DEPARTMENT OF ENVIRONMENTAL MANAGEMENT
OFFICE OF WATER RESOURCES
OWRS & FRESHWATER WETLANDS
JOINT PERMIT APPROVAL
OWRS# 1703-1212 PROJECT# 23-0181
APPROVED: [Signature] DATE: 12/12/24
No Changes Allowed Without RIDEM Approval
Approved Plans/Permit Must Be Kept at Construction Site

ONSITE WASTEWATER TREATMENT SYSTEM & WETLANDS PLAN

ASSESSOR'S PLAT 139 LOT 17
EAST WALLUM LAKE ROAD
BURRELLVILLE, RHODE ISLAND

SHEET 1 OF 2

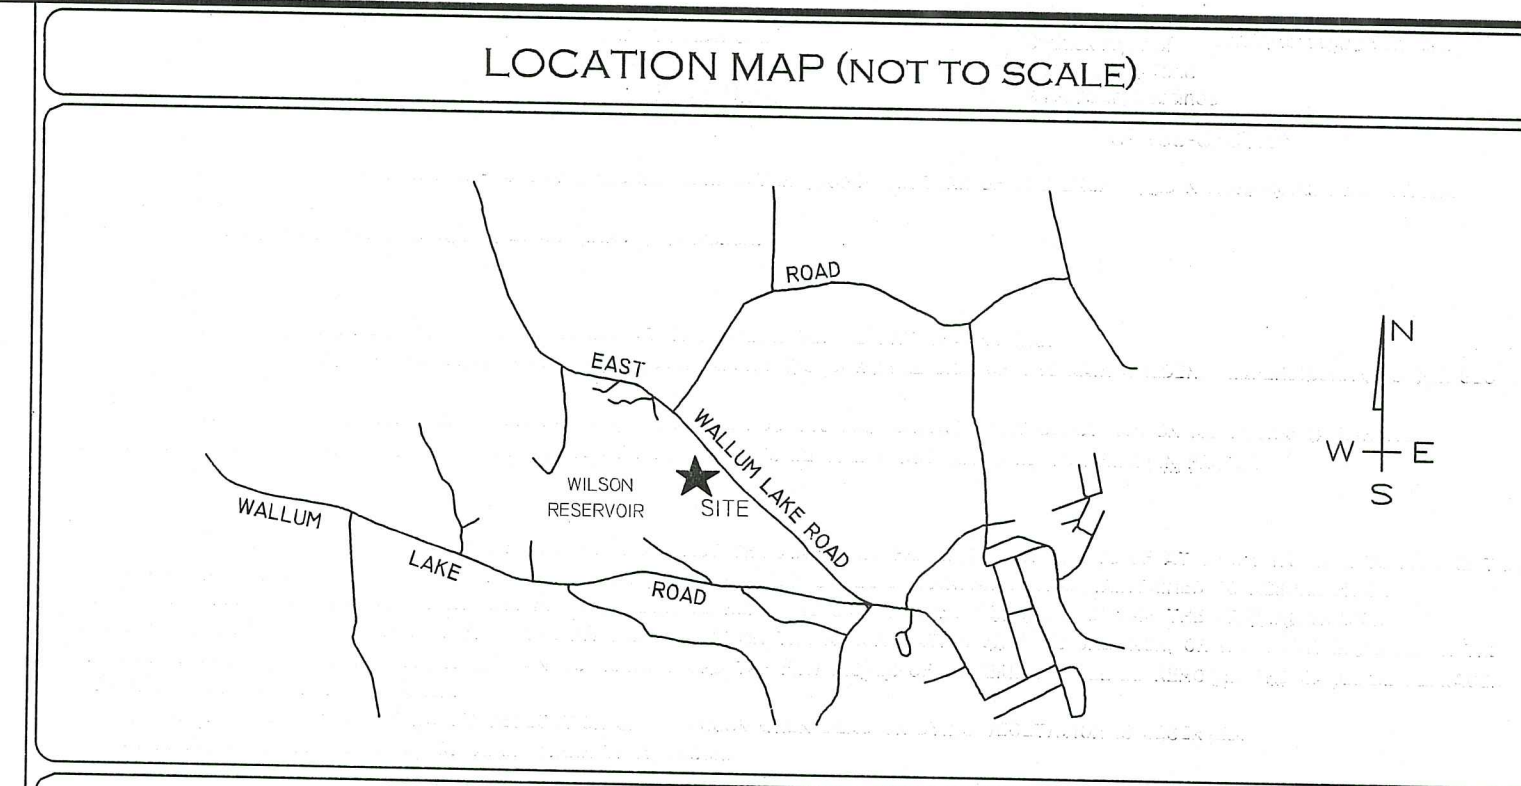
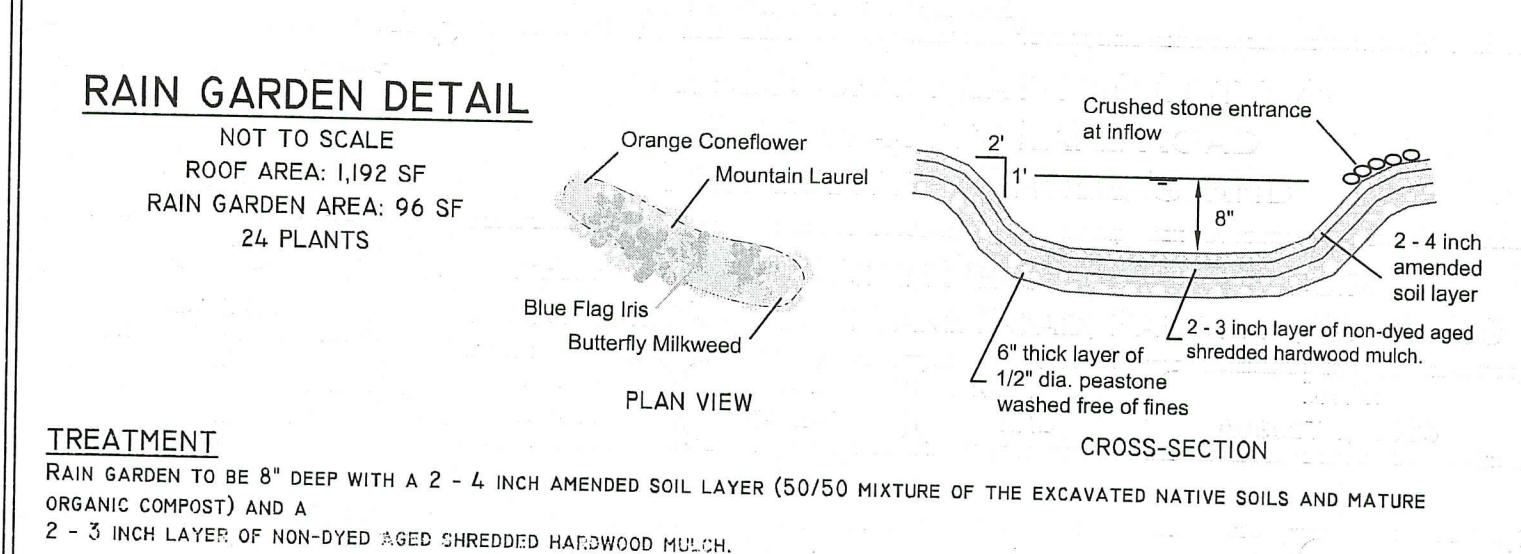
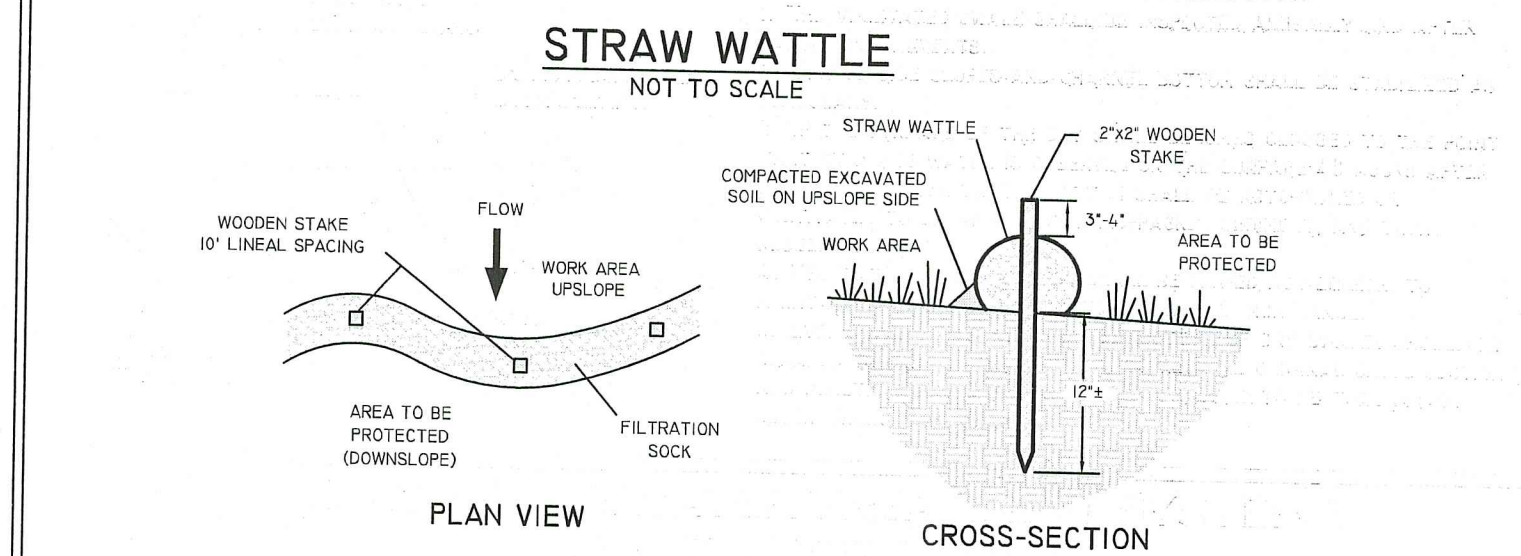
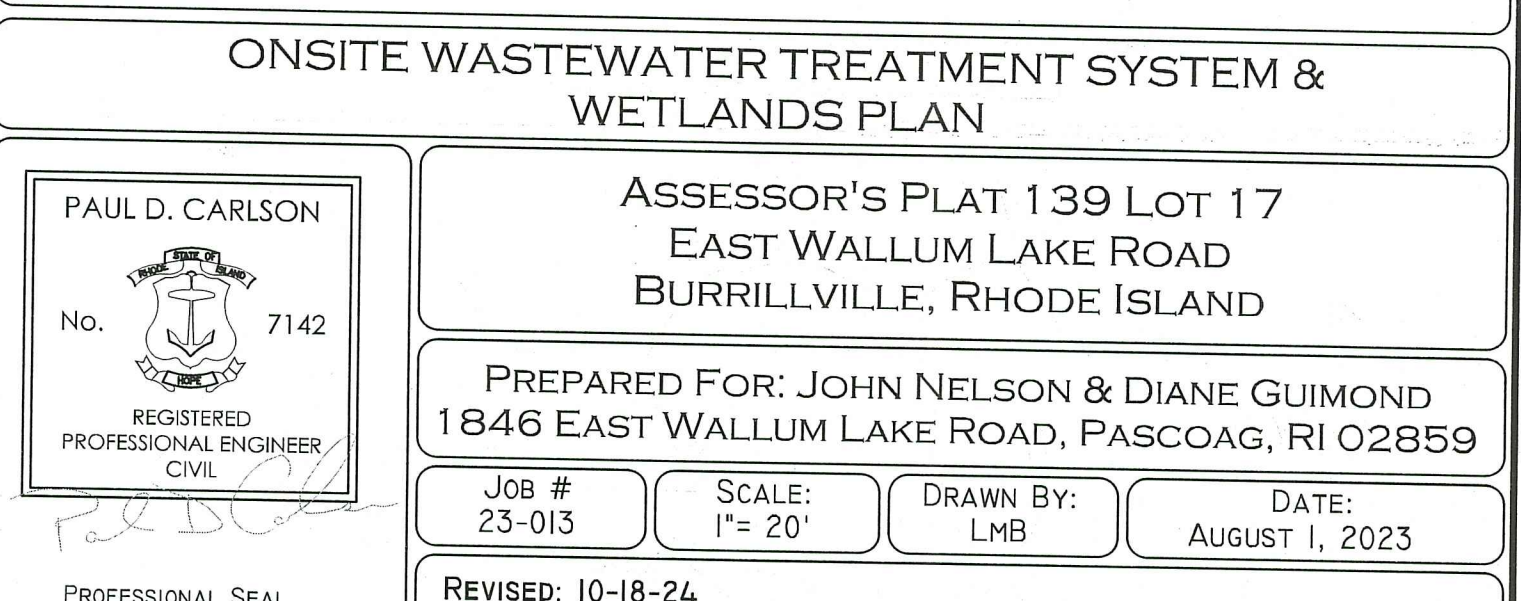
The Depicted "East Drive"
Has not been Approved Per RIDEM.

SHEET 2 OF 2

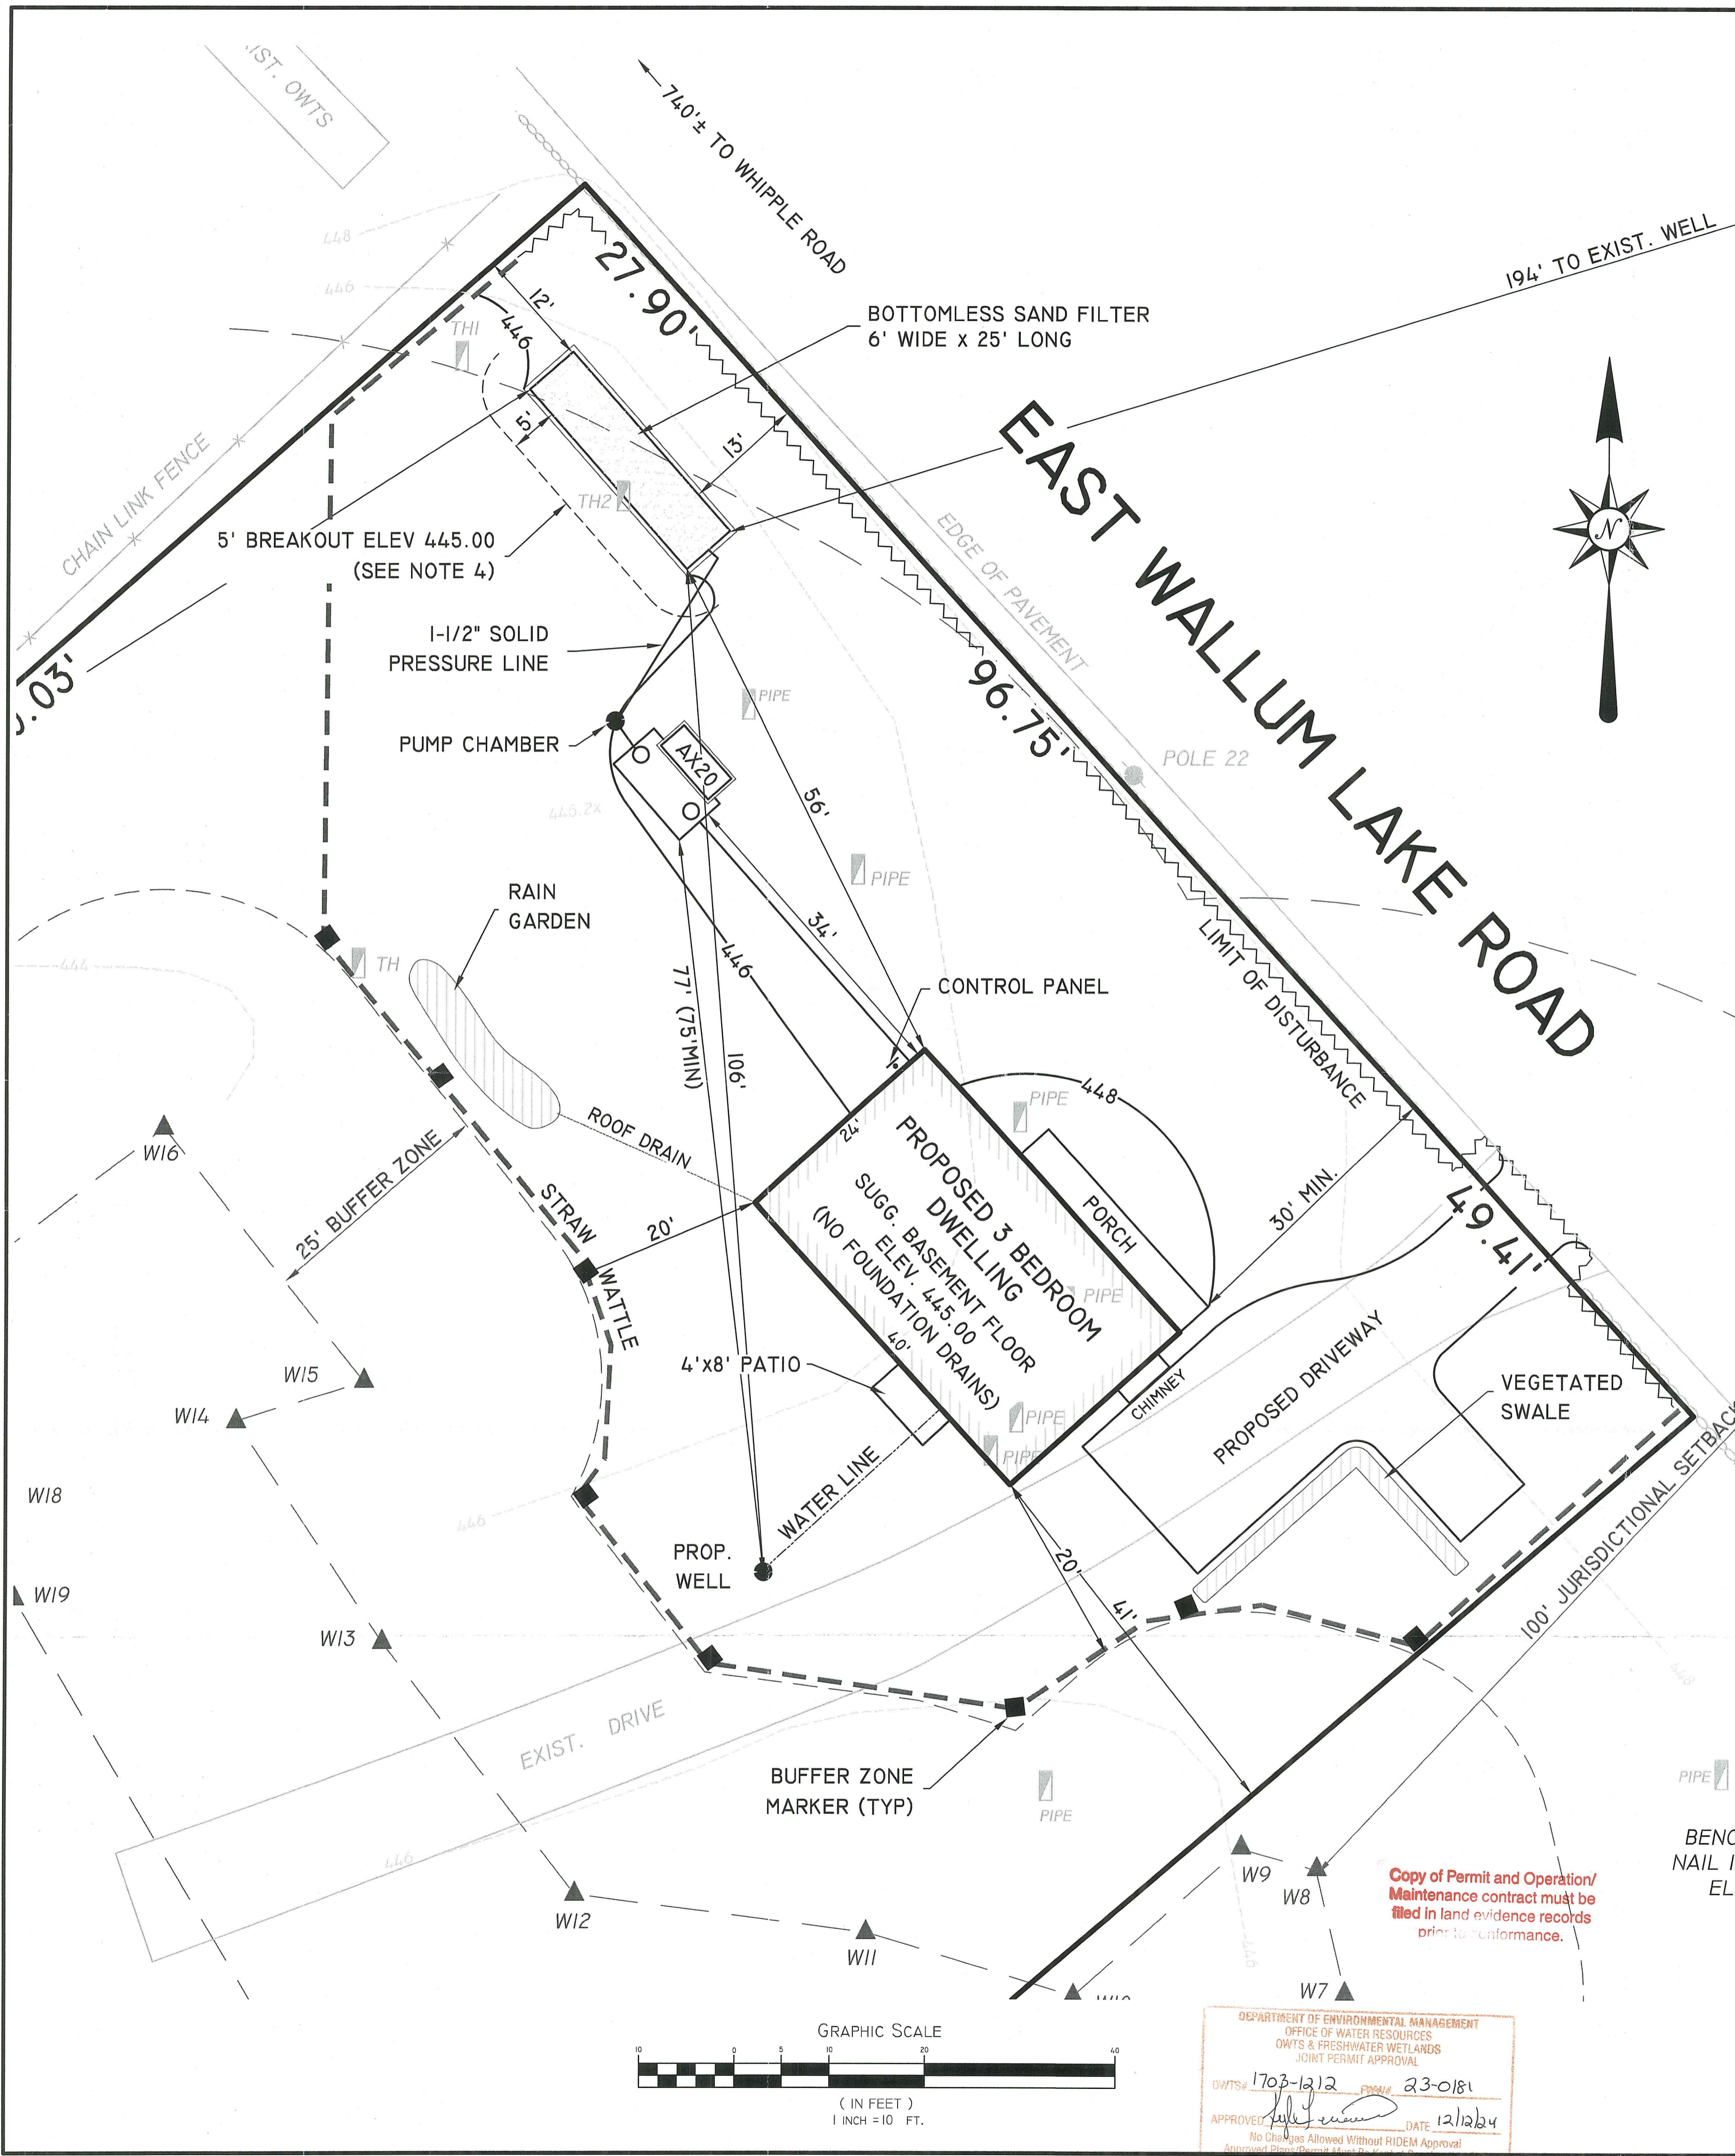
Copy of Permit and Operator/
Maintenance contract must be
filed in land evidence records
prior to conformance.
